Final Environmental Impact Report

CANDLESTICK POINT–HUNTERS POINT SHIPYARD PHASE II DEVELOPMENT PLAN PROJECT

Volume IV: Final EIR Comments & Responses (Section A through Letter 49)

SAN FRANCISCO REDEVELOPMENT AGENCY
File No. ER06.05.07

FIGURE III.K-5

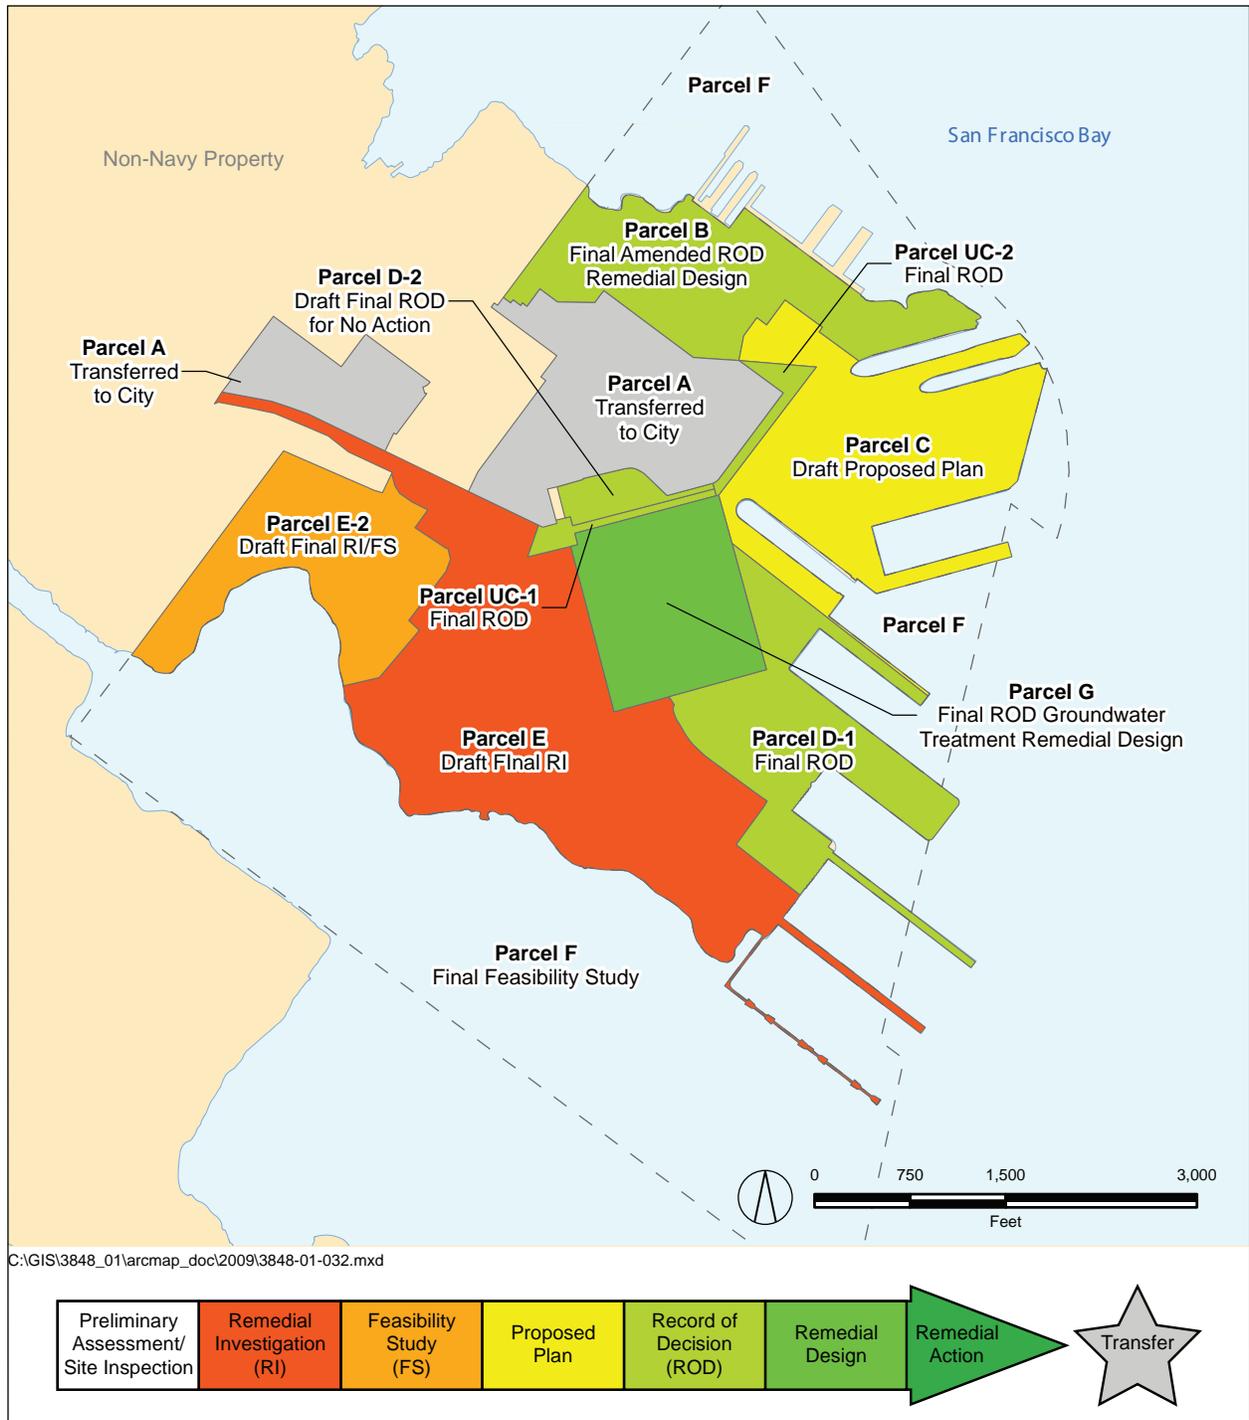
- Inquiring about the status of the cleanup on the various Shipyard parcels

Candlestick Point — Hunters Point Shipyard Phase II EIR
HUNTERS POINT SHIPYARD PHASE II NAVY PARCEL OVERLAY

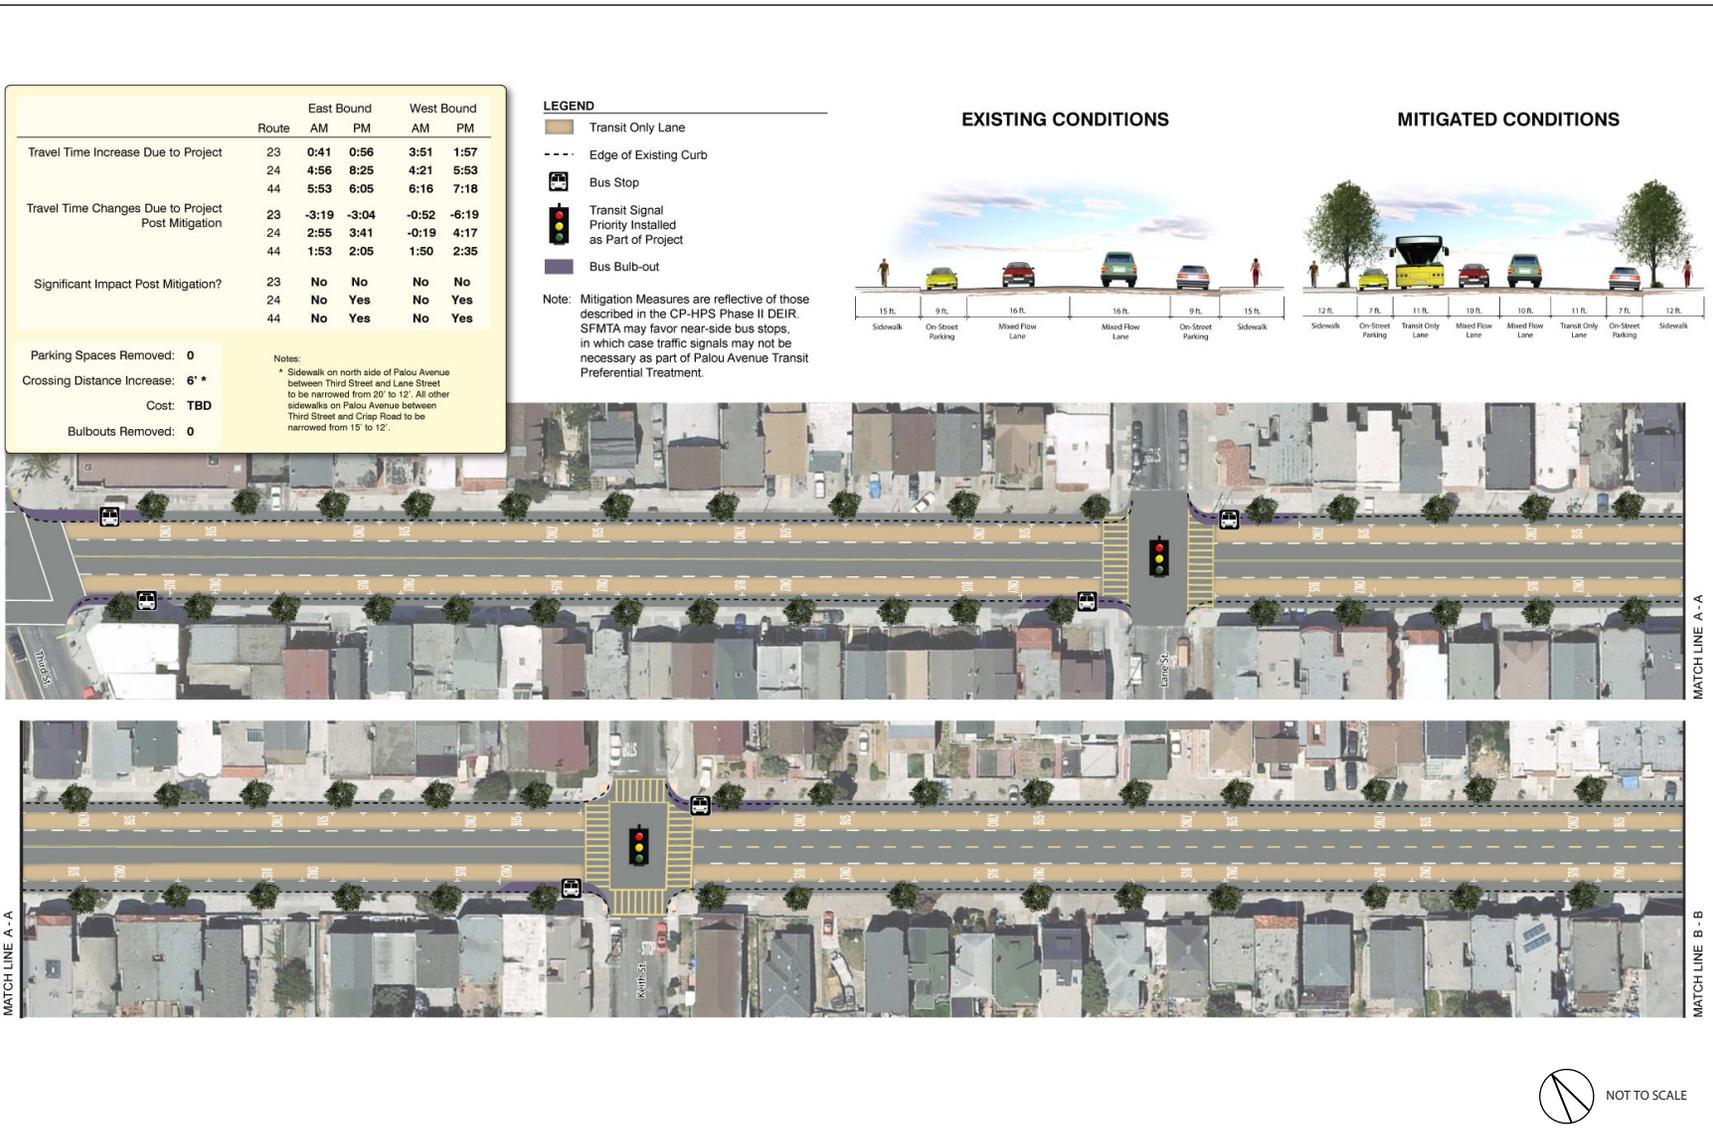
Mitigation measure MM TR-22.1 included a number of optional improvements to the Palou Avenue corridor aimed at reducing Project-generated transit delays. Subsequent to publication of the Draft EIR, the Project Applicant and SFMTA conducted a feasibility study. The fifth bulleted item in MM TR-22.1 was determined to be the most desirable of the optional measures because it would provide continuous transit-only lanes along the entire length of Palou Avenue between Crisp Avenue and Third Street, the transit-only lanes could be in operation at all times, and this option would retain on-street parking along the primarily residential corridor.

Specifically, as currently envisioned, mitigation measure MM TR-22.1 would add a transit-only travel lane in each direction on Palou Avenue between Crisp Avenue and Third Street. To accomplish this without removing existing on-street parking along Palou Avenue, existing sidewalks would be narrowed from 15 to 12 feet, allowing a 7-foot on-street parking lane, an 11-foot transit-only lane, and a 10-foot auto travel lane in each direction. The resulting 12-foot sidewalk widths would remain consistent with the City's Draft Better Streets Plan. Further, so-called "bus bulbs" could be provided at corners with bus stops, to provide additional passenger waiting areas and amenities, reduce pedestrian crossing distances, and eliminate the need for buses to pull over to the curb at stops. There would be no additional loss of on-street parking associated with this mitigation measure.⁷⁴ Because Palou Avenue between Keith Street and Third Street already has two westbound lanes, mitigation measure MM TR-22.1 would convert one of the two auto travel lanes to transit-only. Levels of service for westbound traffic on Palou Avenue between Keith Street and Third Street may deteriorate due to the reduced auto capacity. Otherwise, intersections along Palou Avenue would not experience an associated degradation in auto level of service.

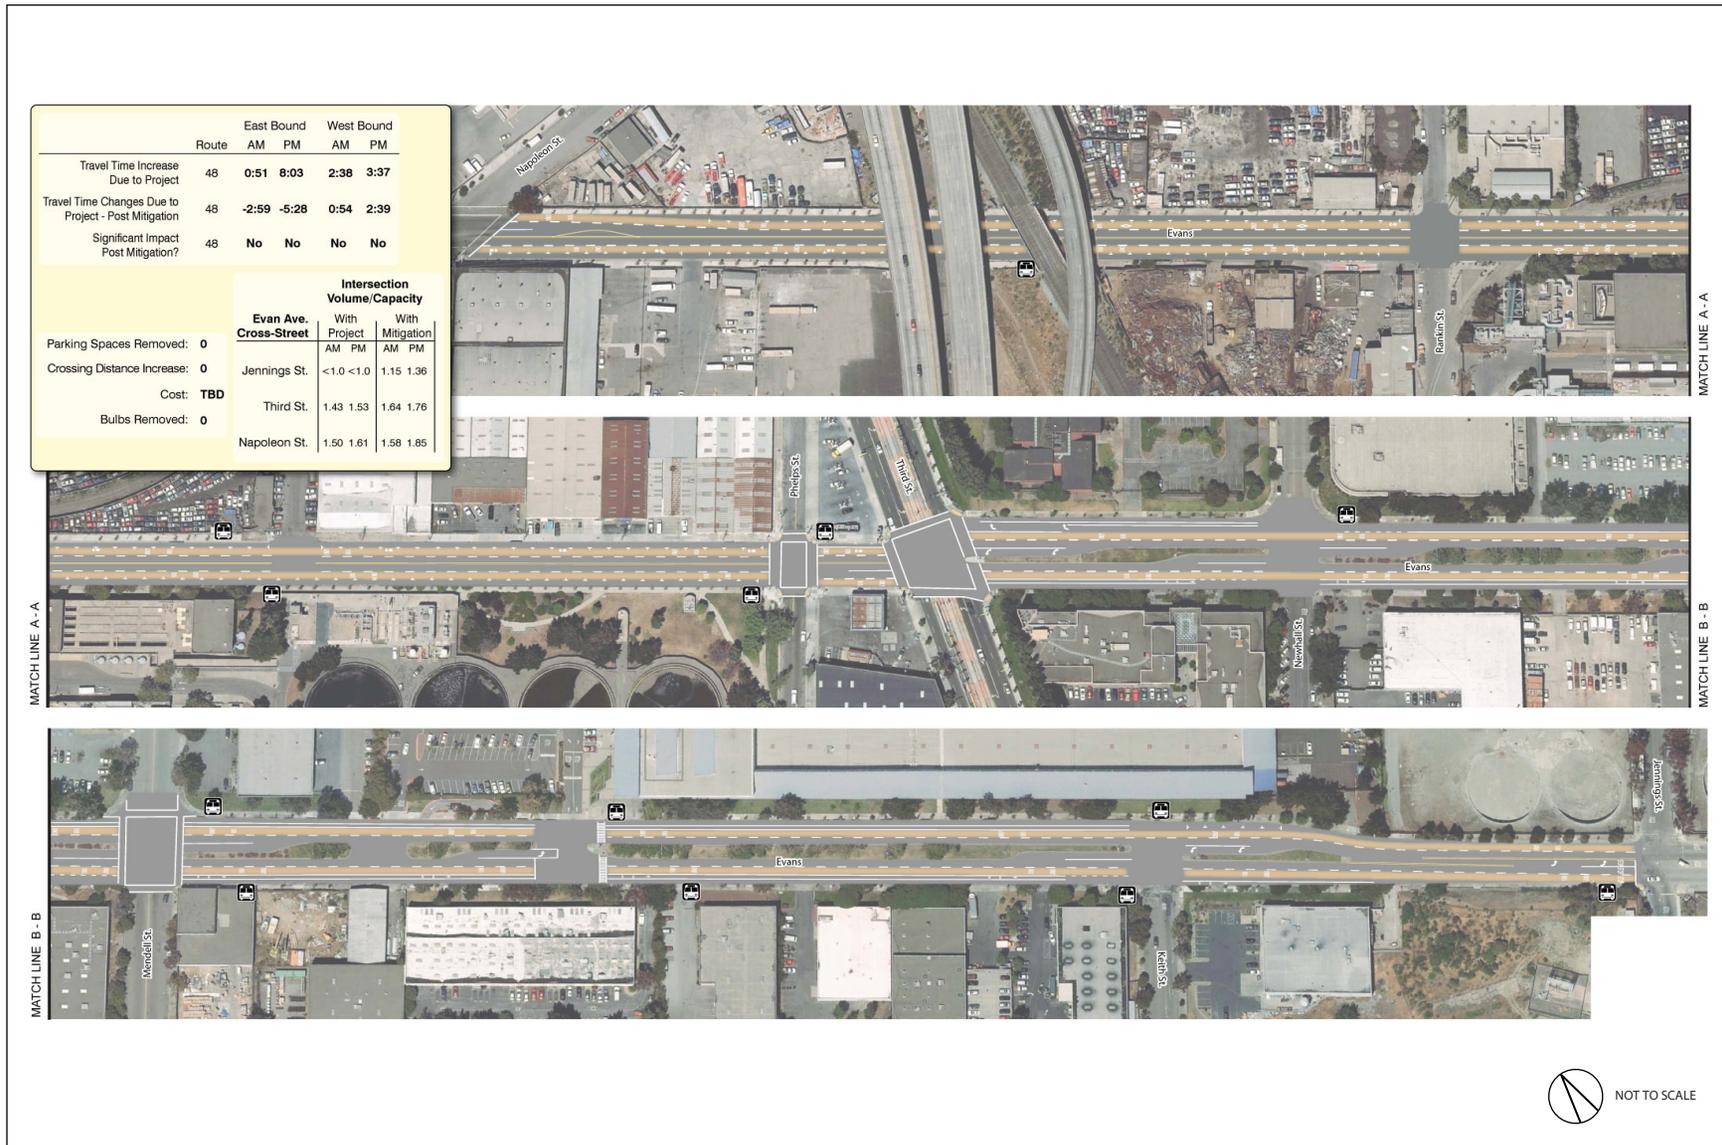
Mitigation Measure MM TR-24.1: Maintain the Proposed Headways of the 48-Quintara-24th Street

Mitigation measure MM TR-24.1 would convert one of the two automobile travel lanes in each direction into a transit-only travel lane on Evans Avenue between Napoleon Street and Jennings Street. There may be a small loss of on-street parking as a result of implementing this mitigation measure if curbside bus zones or bus bulbs are implemented as part of the measure.⁷⁵ As noted in the Draft EIR, implementation of this mitigation measure would exacerbate LOS F conditions for autos along Evans Avenue; however, the effective prioritization of transit circulation over automobile circulation would be consistent with the City's "Transit First" policy.
